SAFETY BULLETIN FROM STANNAH LIFT SERVICES LIMITED RE: 230 MANUAL SWIVEL CHAIRS (PDN06/5571)

230 SWIVEL LOCK - SAFETY MODIFICATION

PDN 06/5571

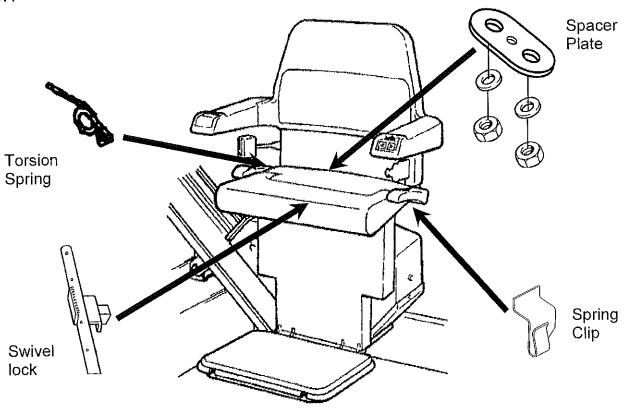
Effective to all 230 models with manual swivel chairs manufactured from May 1995 to April 1997.

The swivel seat can fail to safely lock in position under extreme circumstance of abuse or excessive use. This is due to wear of the swivel lock assembly and has occurred in a few instances with stairlifts permanently in use since 1995.

Stannah is recommending the replacement of the swivel lock assembly at the next routine service. In addition to this, the replacement of swivel lever springs and the fitting of a safety device which consists of a spacer plate and clip will ensure that the levers are fully depressed during operation. This will minimise wear in future.

Retrofit kits - Part No. 230-71B are available free of charge from Stannah.
